CITY OF ALBUQUERQUE

RE: 211 Maple St. NE
Grading and Drainage Plan
Engineer's Stamp Date: 02/28/18
Hydrology File: K15D090

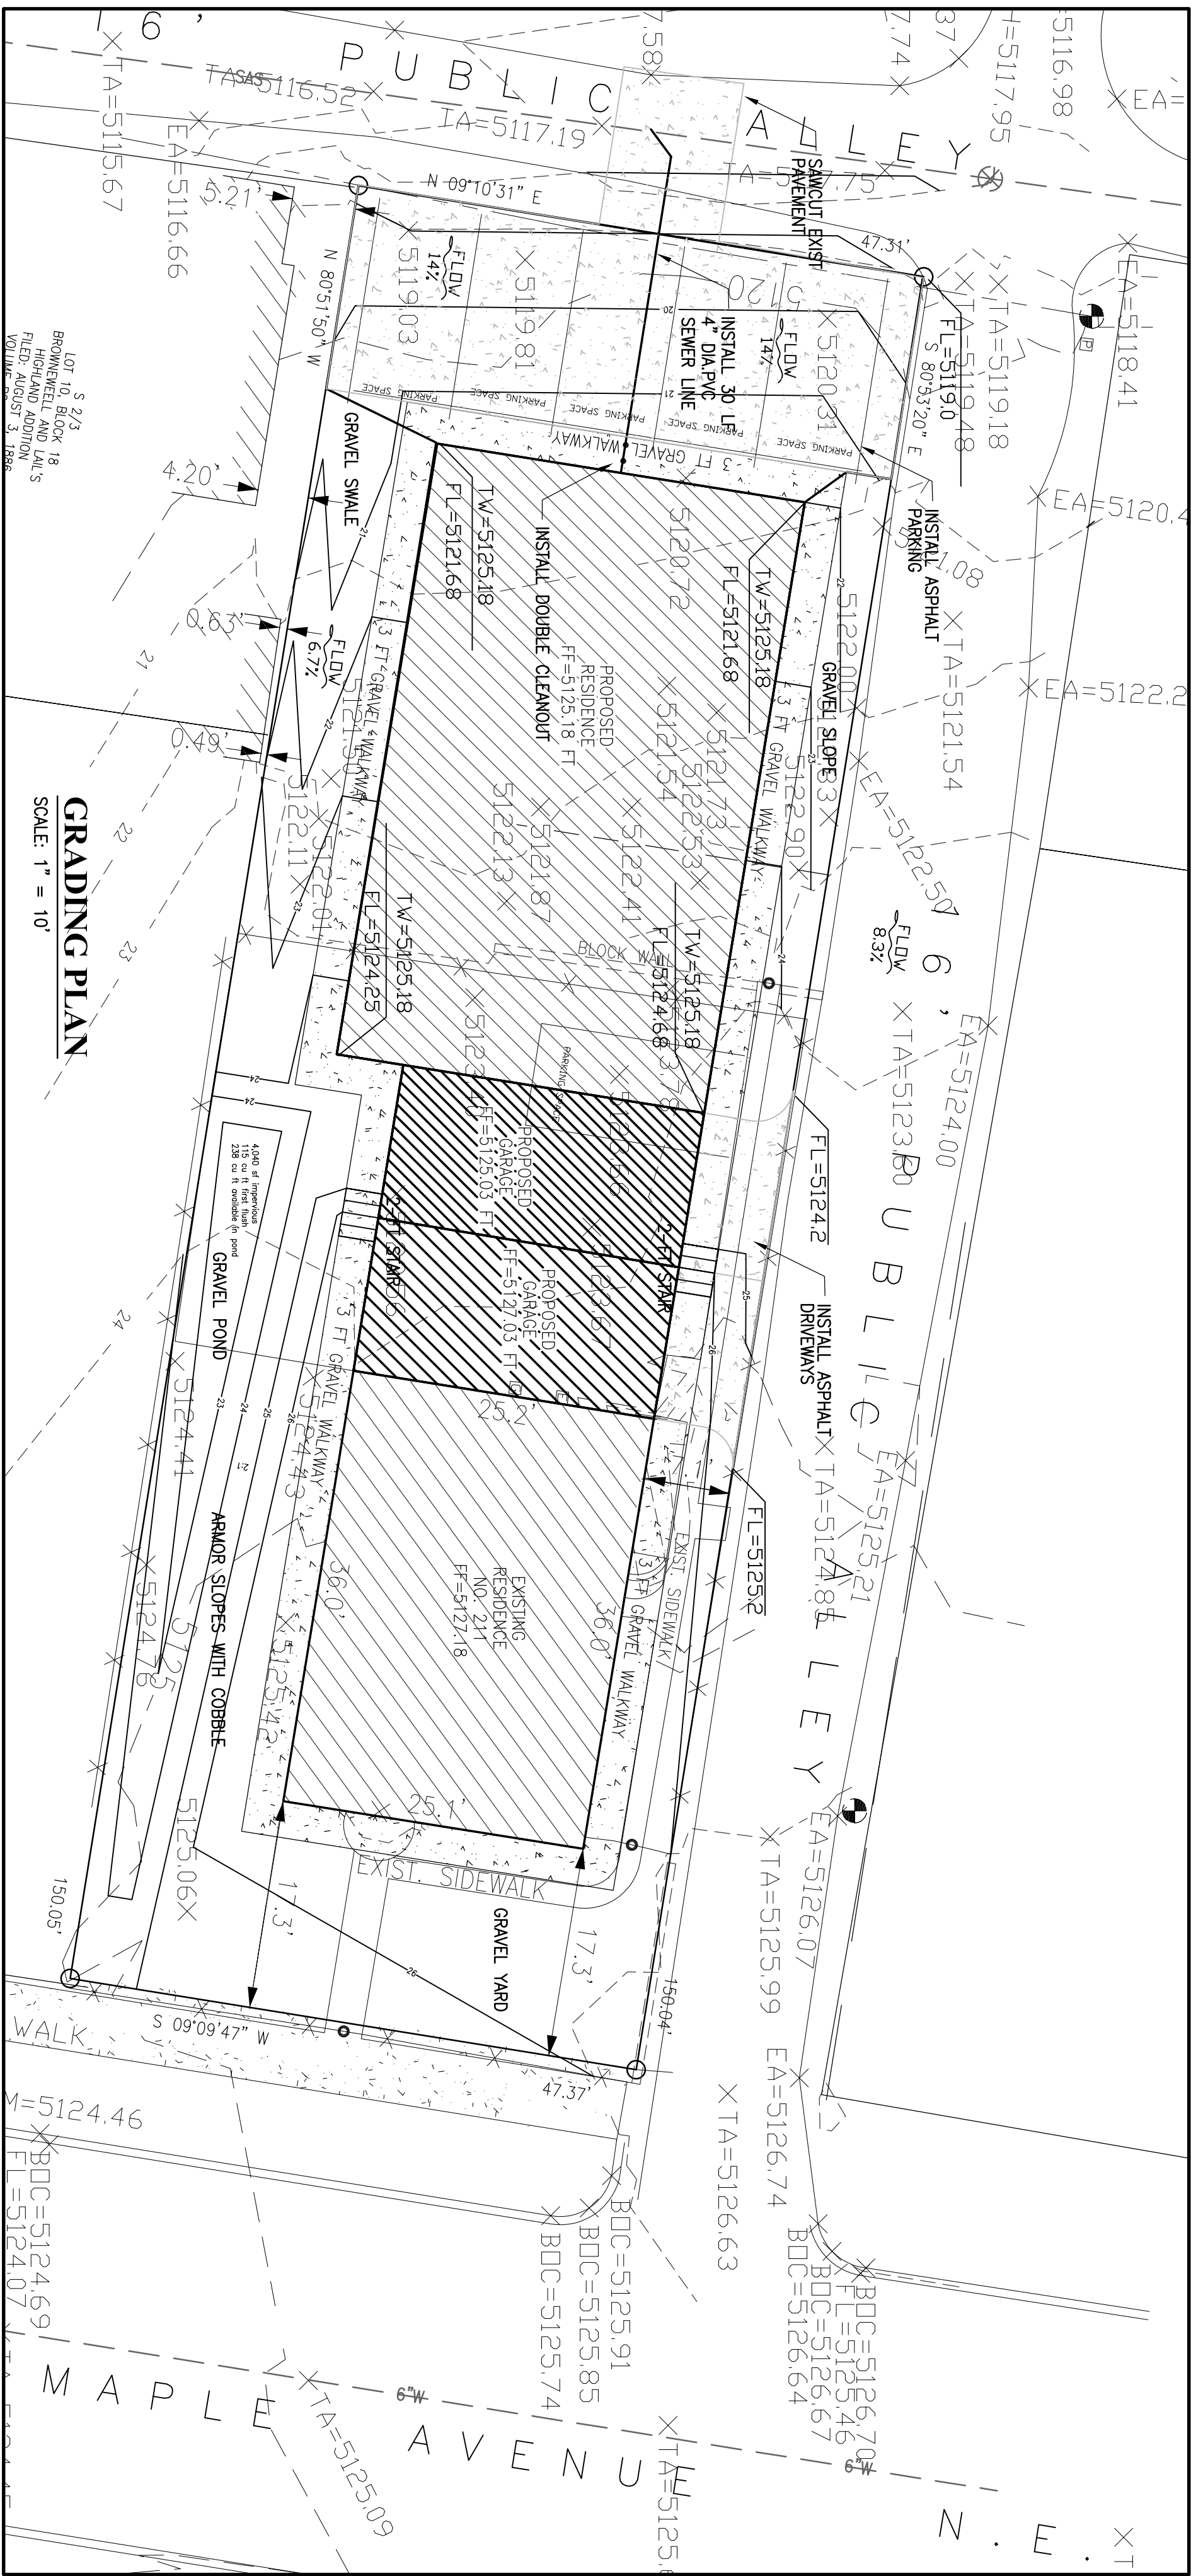
PO Box 1293 Based upon the information provided in your submittal received 05/08/18, the Grading and
Drainage Plan is approved for Building Permit.

NM 87103 Please provide a Private Facility Drainage Covenant per Chapter 17 of the DPM for first
flush pond prior to Certificate of Occupancy. Please submit this on the 4th floor of Plaza de
Sol. A \$25 fee will be required.
